This Service Information Bulletin (Revision 1) replaces SI B61 05 25 **dated March 24, 2025.**

E-Series	Model Description	Production Date
G45	X3 Sports Activity Vehicle	August 1, 2024 – February 12, 2025

BMW AG has issued a Delivery Stop (effective March 21, 2025) on certain Model Year 2025 BMW vehicles that were produced between August 1, 2024, and February 12, 2025.

**Threaded connection points to be tested  
(Power distribution, base Z83\*1B, Z83\*2B and 48-volt battery G14\*2B and G14\*3B)**

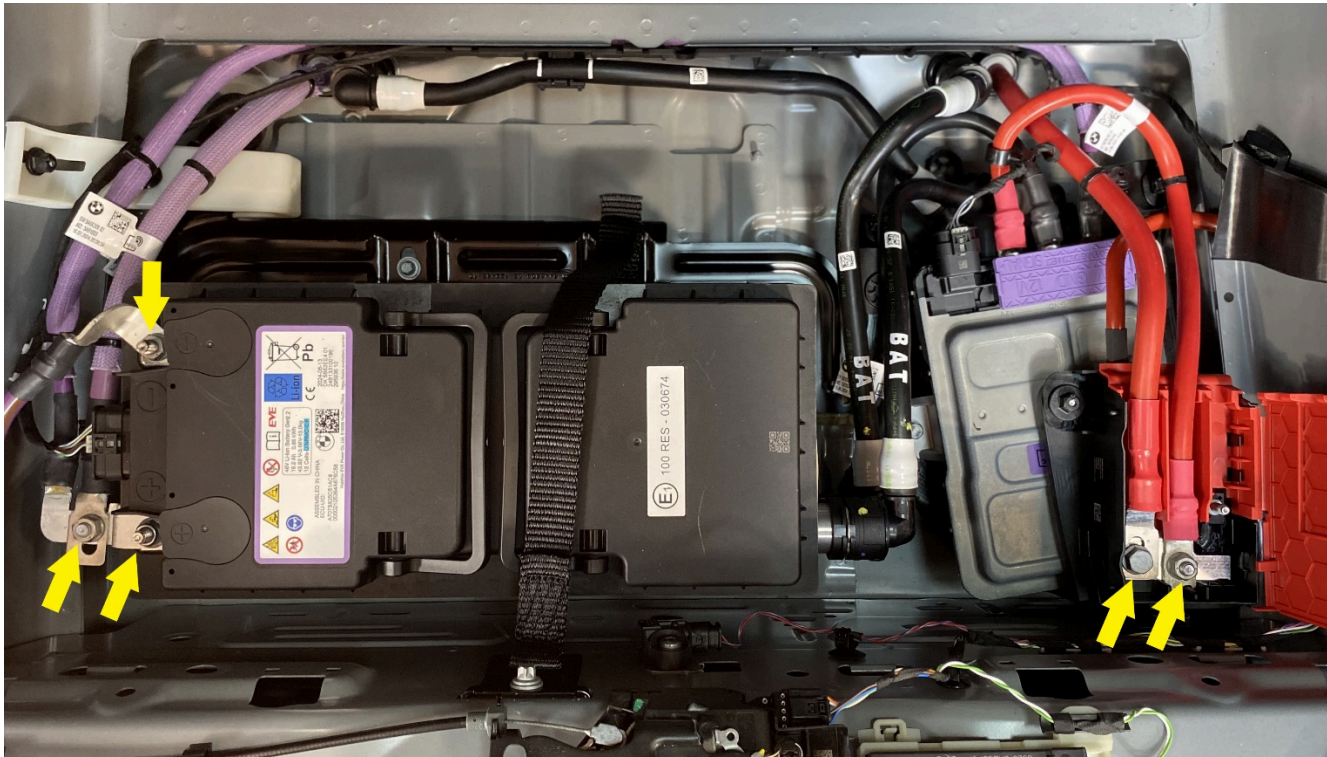
The terminals of the 48V battery may have not been torqued properly. In the event of a loose connection, the vehicle’s electrical system might suffer numerous malfunctions. This is generally indicated by the corresponding Check Control messages (CCMs) that will display.

1. Visual inspect the (5) threaded connection points below marked by yellow arrows. If a loose threaded connections is detected, unfasten the nut and check the connection point (cable shoe, nut, bolt) for damage.

Inspect the threaded connections of the battery cables of the 48V battery, and rework if necessary.

2. When consequential damage is visible: renew the associated cable, nut, 48V battery, distributor, or Power Control Unit (PCU) if necessary. Select and follow the appropriate repair instructions in AIR based on the extent of damage that has occurred.
3. If no consequential damage is visible or found, reassemble the threaded connection points in accordance with specifications.
4. Retorque the threaded connections to **19 Nm** and reassemble the vehicle.
